# Recall Bulletin 250221REV

**RECALL BULLETIN:**  
**250221REV**  
**NHTSA #25V121**  
**TC #2025-107**

**SUBJECT:**  
**Engine Exhaust Tips**

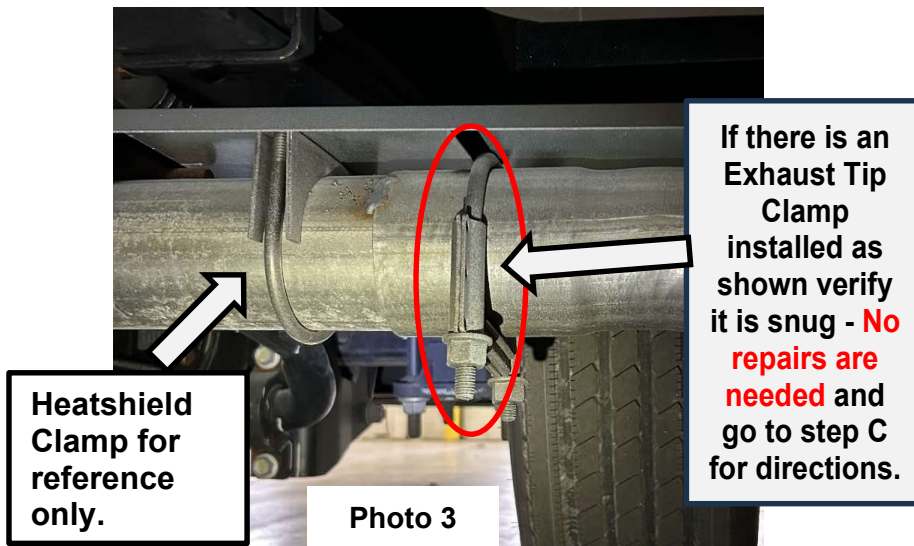
With the engine off, inspect the exhaust mounting and installation. See photo 1 and 2 to validate if repairs need to be completed or not.

- A.** Inspect to determine if the main exhaust has a hanger mounting bracket as outlined in photo 2, if no bracket exists go to the repair procedure. See photo 1. Note: The bracket is not required but just assists with identifying if a repair is needed. However, if the **main exhaust hanger mounting bracket does exist** as shown in photo 2, go to Step B for further validation.

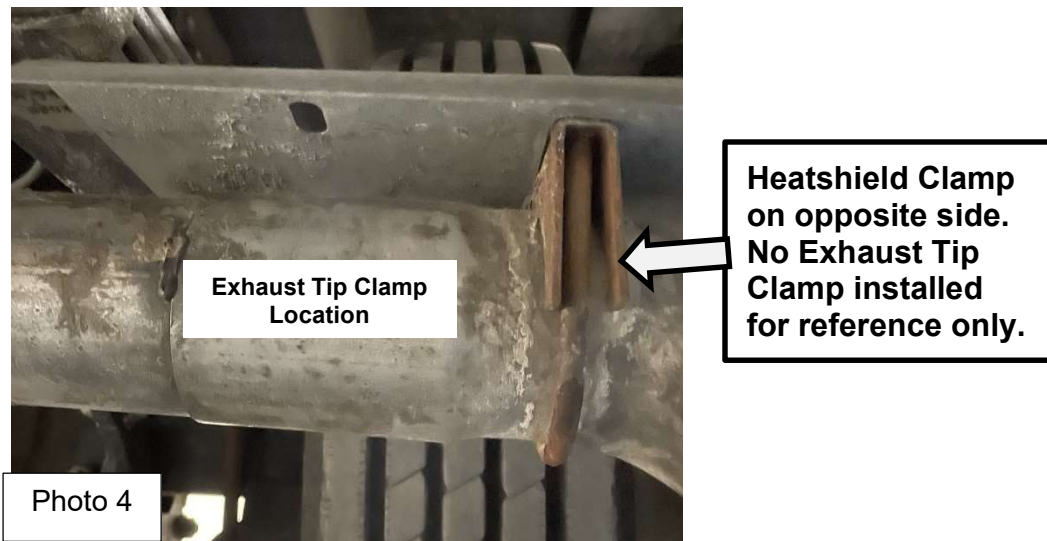
- B. Look where the exhaust tip connects to the main exhaust pipe. Determine if there is a clamp attaching the exhaust pipe to the exhaust tip. If the clamp is missing, go directly to the repair procedure in the next section. **Note: Do not be confused with the clamp adhering the main exhaust pipe to the heat shield. The heatshield clamp is important but is not the primary focus of this repair procedure.**

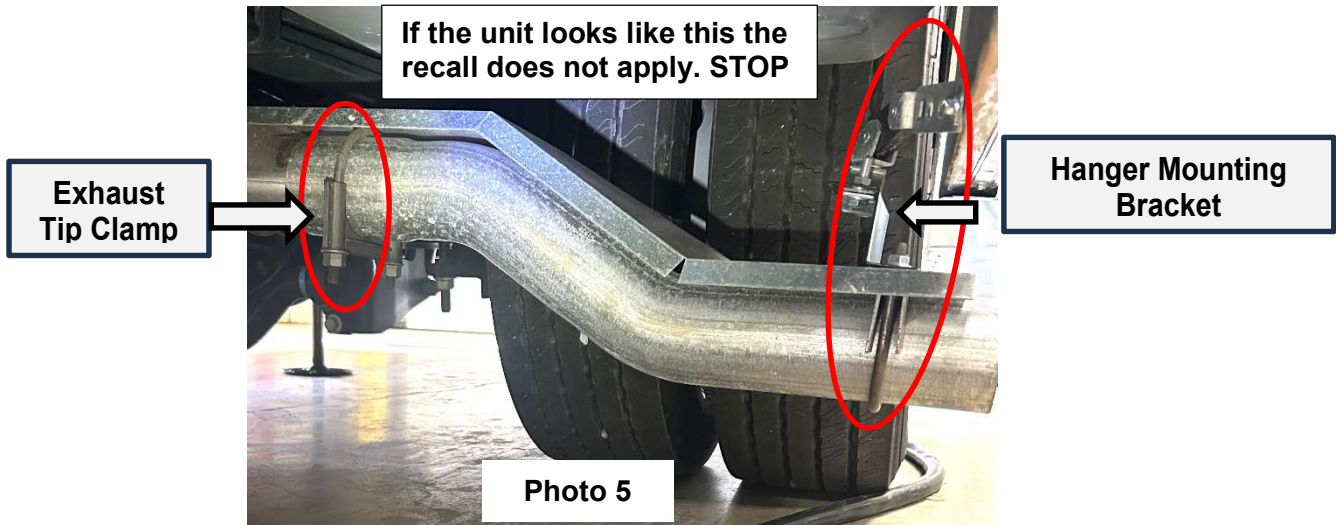
Variation: On some models the Heatshield Clamp may be on the opposite side of where the exhaust tip clamp is or needs to be installed. See photo 4.

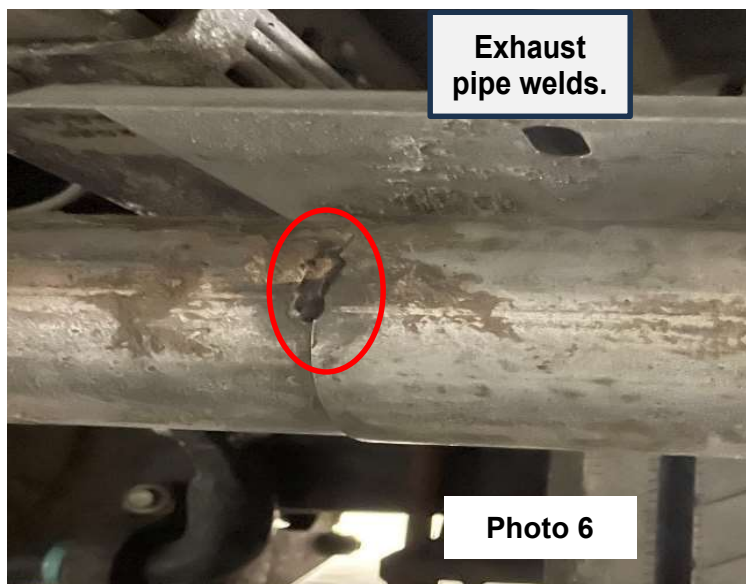
- C. If **both** the hanger mounting bracket and the clamp are installed as shown in photo 5 below, file a warranty request for inspected and found **NOT** defective and use Flat Rate **Code 6320 11. No other work is required.**

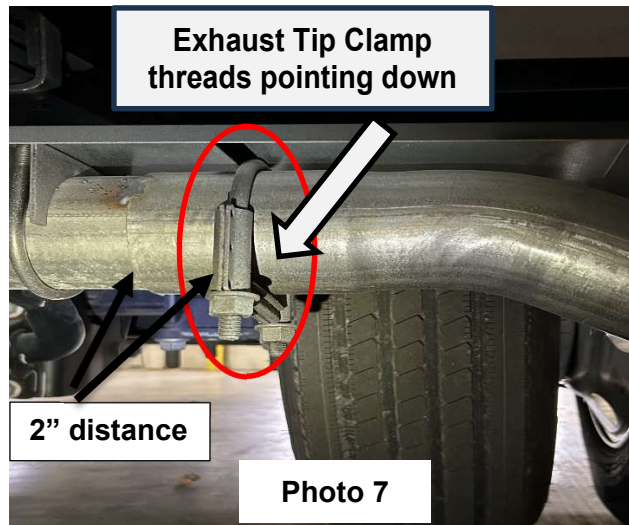
1. Inspect the welds on the main exhaust pipe where the tip attaches. See photo 6. If they are intact, proceed to step 3. If it is not intact, proceed to step 2.

2. If the welds are broken, make sure to reorient the exhaust pipe tip by hand, to ensure it properly extends beyond the outer edge of the sidewall vertical plane, so gases discharge away from the vehicle.

3. Once the orientation is verified in step 2, locate the exhaust clamp purchased from REV RV, or McMaster-Carr designated in this procedure.
4. Disassemble the clamp/nuts to better position it onto the inboard part of the exhaust tip.
5. The exhaust clamp should be approximately 2 inches away from the main pipe to the tip transition. Clamp threads should point downward to allow U-Bolt bend to fit in clearance slot as shown. See photo 7.

1. Install the clamp as positioned in photo 7.
2. Tighten the clamp equally on each side.
3. As the clamp is getting snug, be sure to torque the clamp nuts to **40 foot/pounds** with a certified torque wrench.
